Project Name: CFPUA Water Street Infrastructure / PS 9 Improvements

Subject: TRC Response Letter

CAPE FEAR PUBLIC UTILITY AUTHORITY
WATER STREET INFRASTRUCTURE / PS9 IMPROVEMENTS
 GENERAL
INFORMATION AND PLANS FOR TRC REVIEW

DATE: NOVEMBER 2019	SCALE: HORIZONTAL: N/A	G00.1 DRAWING NUMBER
MCE PROJ. # 05367-0030	VERTICAL: N/A	
DRAWN: MTN		REVISION
DESIGNED: STM		
CHECKED: STM		
PROJ. MGR.: AWB

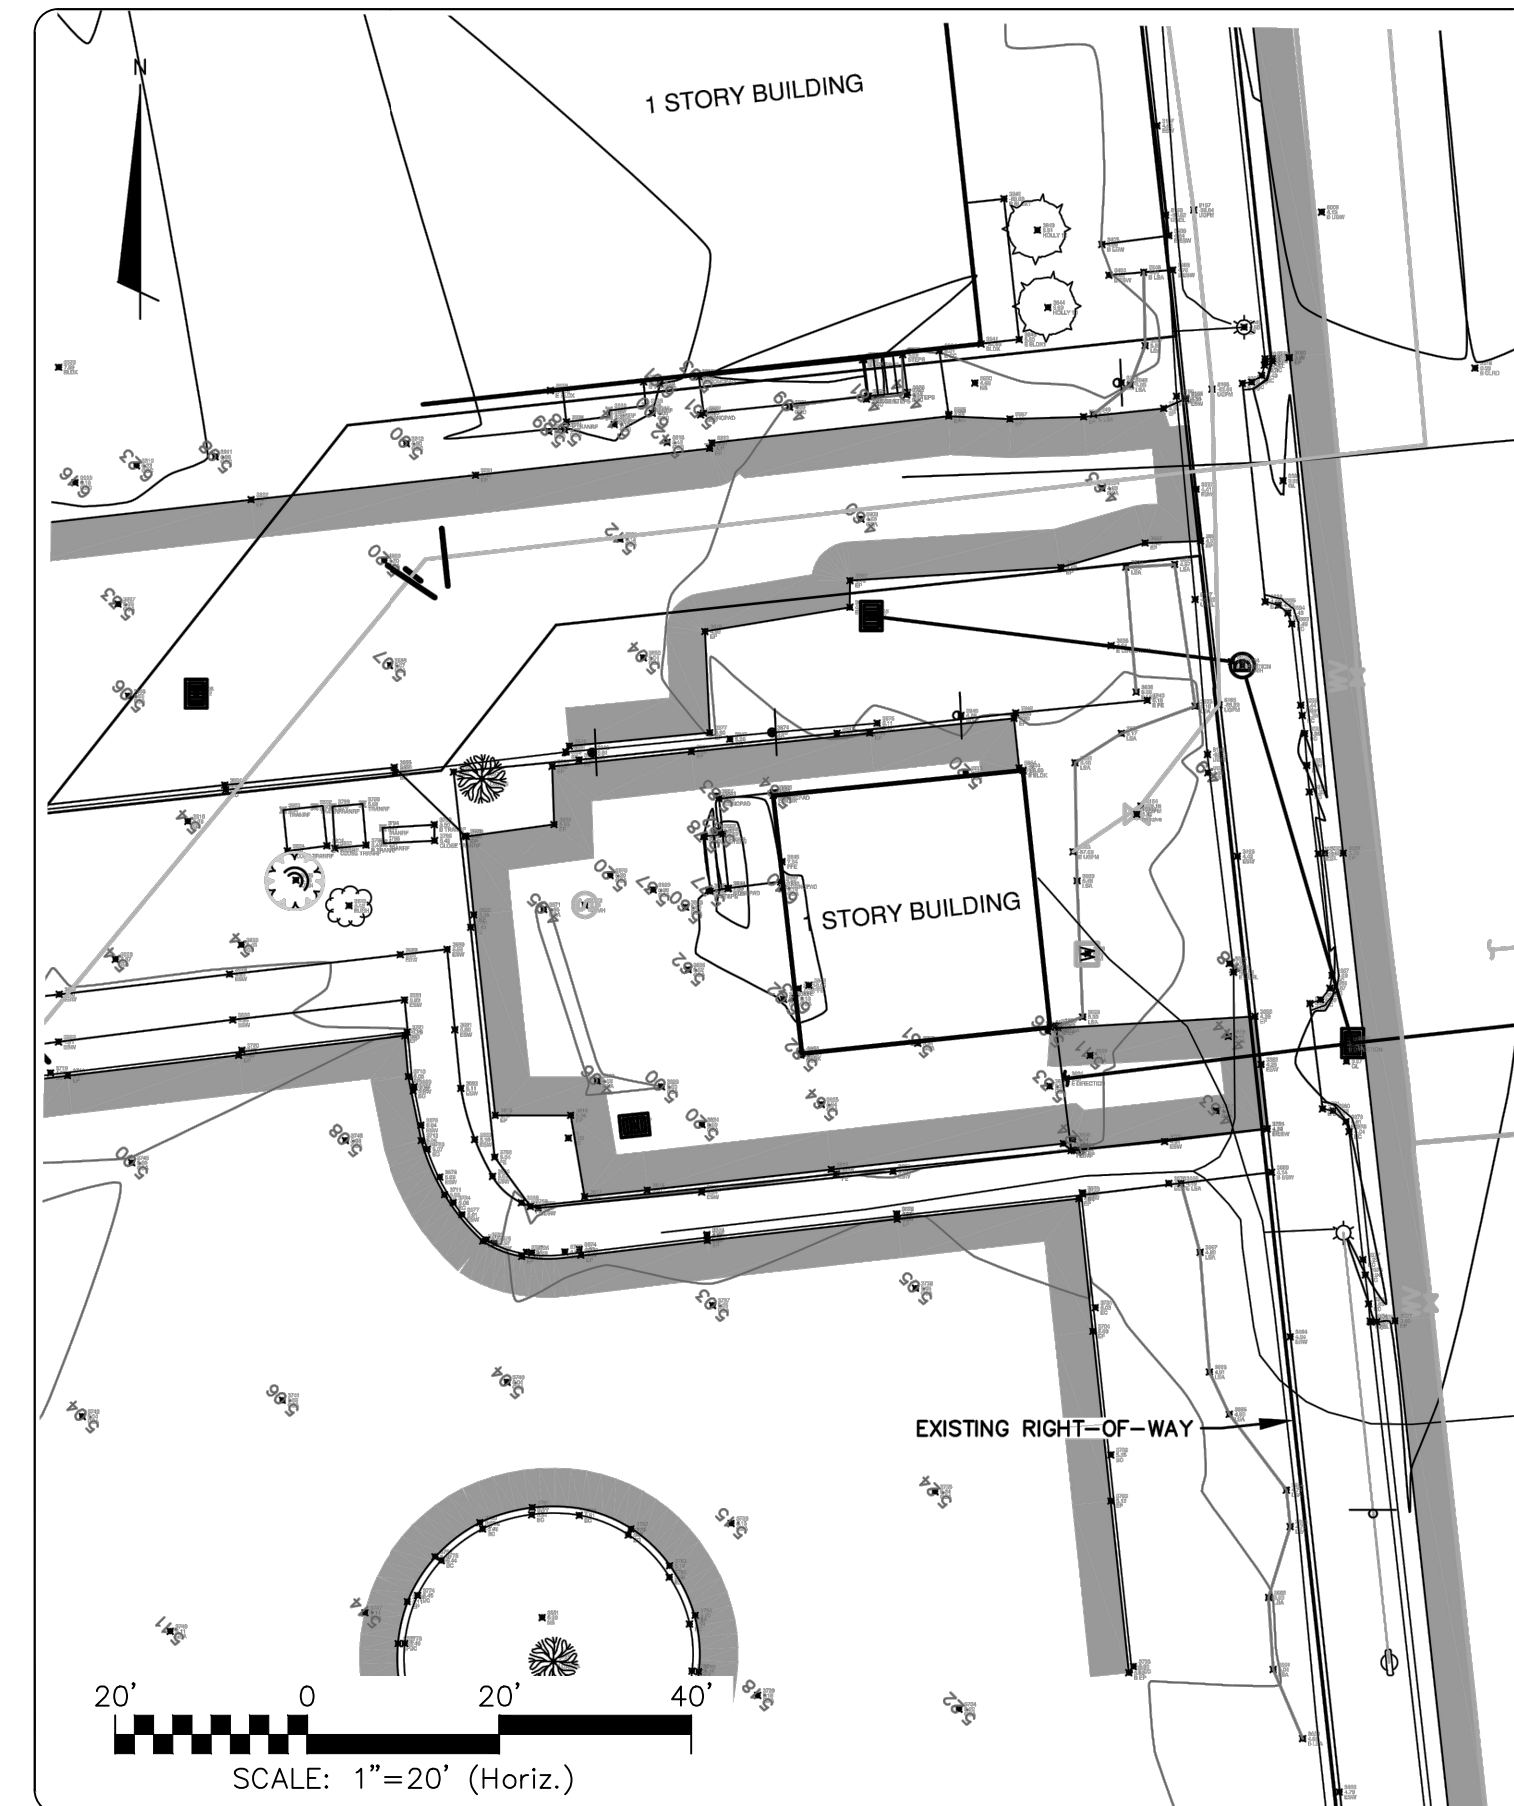
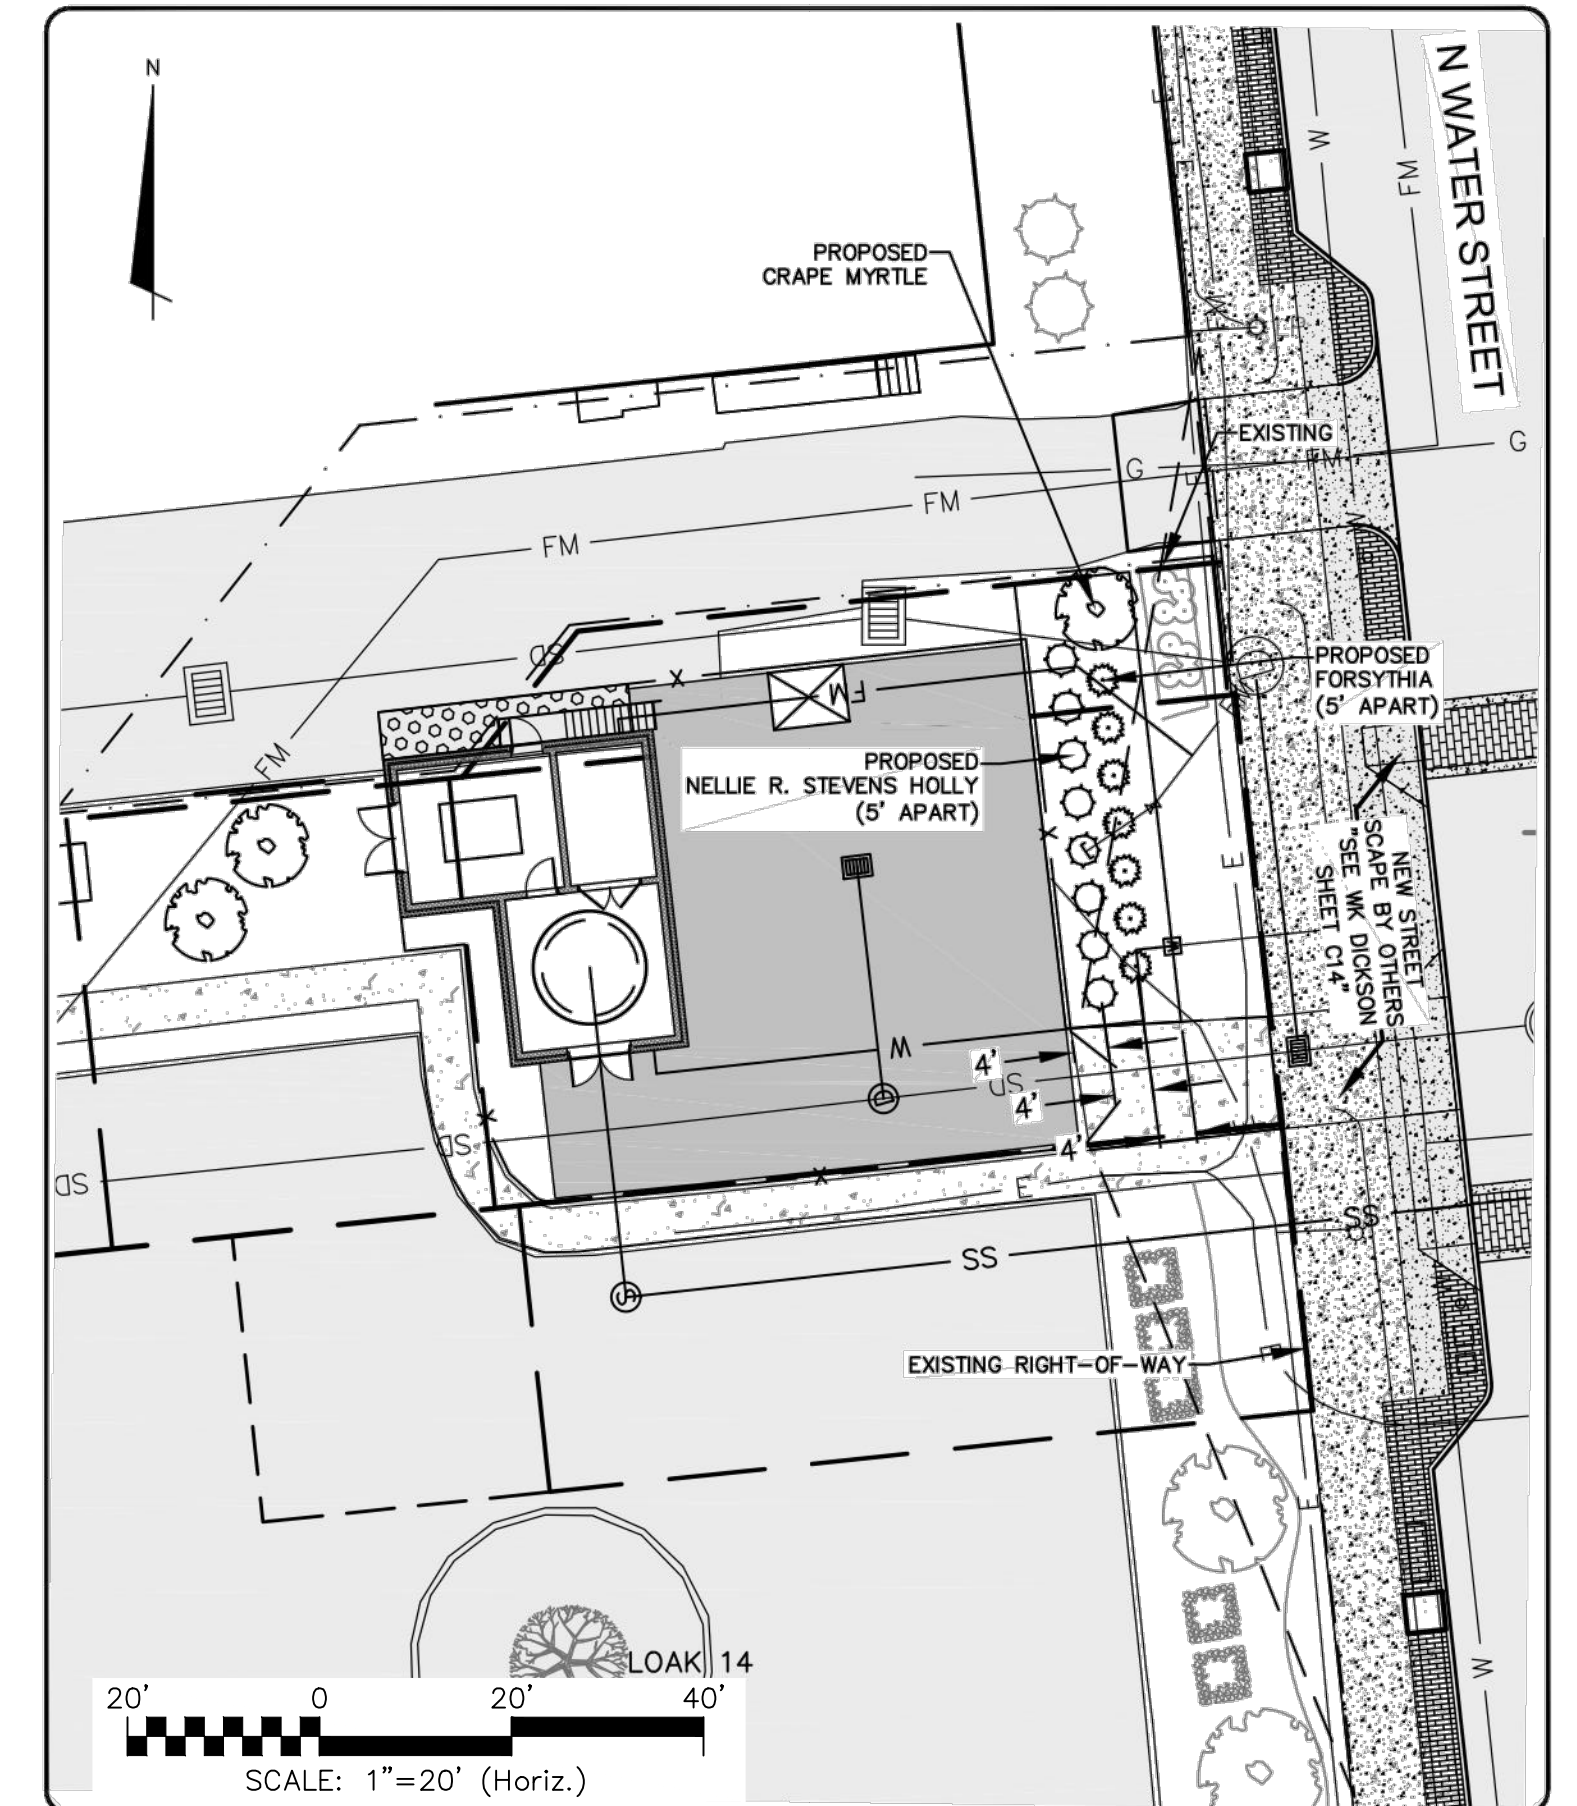
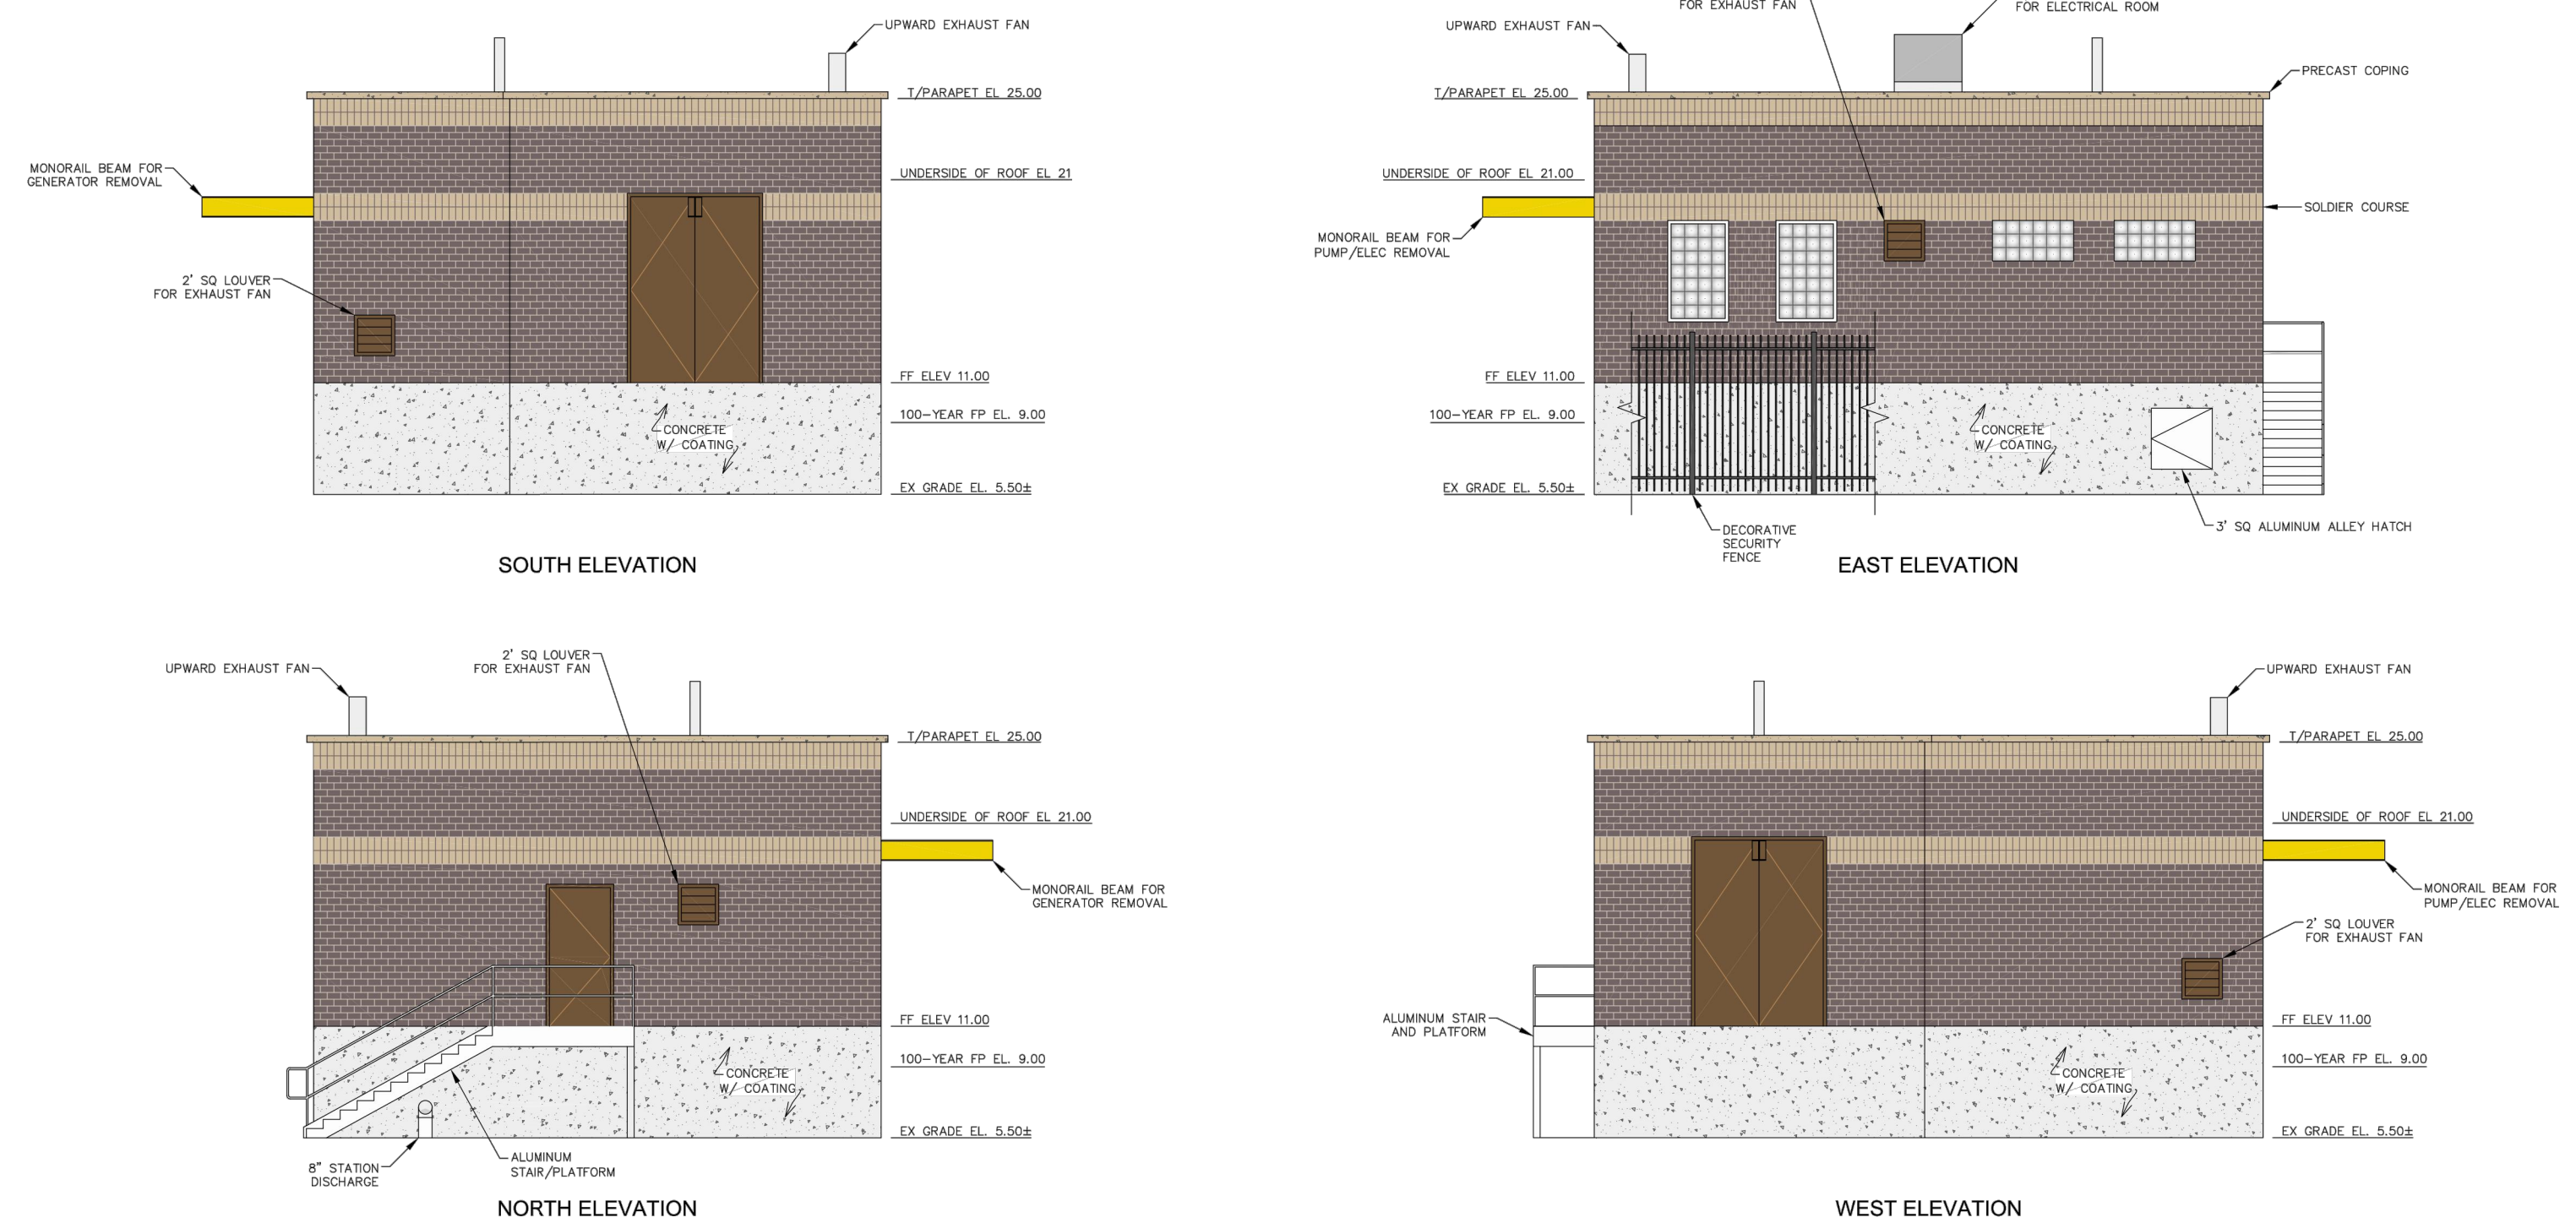
4. Show driveways for adjacent lots and lots across the street. Please let me know if you have any questions or if I can be of further assistance as this development moves through the review process.

7. Sec. 18-60 (c) (1): Show a vicinity map showing the position of the subdivision with relation to surrounding streets, oriented in the same direction as the site plan.

8. Sec. 18-60 (c) (2): Show true North pointing towards the top of the map of both plan and location map.

9. Sec. 18-60 (c) (15): Show a proposed landscape plan. Mark on plans all proposed trees to be removed.

16. Variance Needed: Massing and scale. Large expanses of flat, unadorned walls are prohibited. Facades shall incorporate architectural details, particularly at the pedestrian level. Building facades shall incorporate periodic transitions across the facade as stated below. The following design element standards shall apply to all new construction where applicable:

- a. Building facades shall be divided into distinct massing elements utilizing methods including but not limited to facade offsets, pilasters, change in materials, or fenestration (window arrangement). Transitions shall be no further apart than two-thirds of the height of the facade. The predominant orientation of fenestration within the facade shall be vertical.

- b. The exterior expression of the height at the street-level facade shall be no less than thirteen (13) feet, which may be delineated by methods including, but not limited to incorporation of a distinct horizontal architectural member, facade offsets, or a change in materials (not solely color) or fenestration.

- c. Roofs shall be flat (low slope) with parapet walls, of barrel construction, or have a minimum pitch of four to twelve (4:12)
See Attachment A sheet G00.1 which includes a revised pump station building design with a flat roof and parapet walls.

- a. Show location for compliance.

20. Accurately illustrate the existing conditions on and surrounding this parcel. Show all adjacent traffic signs, lane configurations, traffic control devices and pavement markings on the site inventory plan. Please refer to the Technical Standards and Specifications Manual (link is below) Ch. VII C.1.a.2. for specific information and distance requirements. Contact Traffic Engineering at 341-7888 if you need assistance locating these elements.

See Attachment A for revised plan sheet G00.1 which includes a vicinity map showing driveway locations for adjacent lots and lots across the street.

See Attachment A sheet G00.1 which includes a vicinity map showing the position of the pump station with relation to surrounding streets, oriented in the same direction as the site plan.

See Attachment A sheet G00.1 with true North pointing toward the top of the map on both plan and location map.

See Attachment A sheet G00.1. for the proposed landscape plan. See Attachment C for the tree removal plan which shows all proposed trees to be removed and replaced.

See Attachment A sheet G00.1 which includes a revised pump station building design with distinct massing elements utilizing change in materials. The transition is no further than two-thirds apart.

See Attachment A sheet G00.1 which includes a revised pump station building design with an exterior expression which is no less than thirteen (13) feet. The revised design includes a change in material and color.

See Attachment A sheet G00.1 which includes a revised pump station building design with the HVAC unit placed on the roof. No electrical equipment shall be located on street frontages and shall be screened from the right-of-way. No through-wall mechanical units are to be used for this pump station.

See Attachment A sheet G00.1 which includes a vicinity map with existing conditions on and surrounding the parcel. The revised plan sheet includes traffic signs, traffic flow direction arrows, lane configurations, and pavement markings.
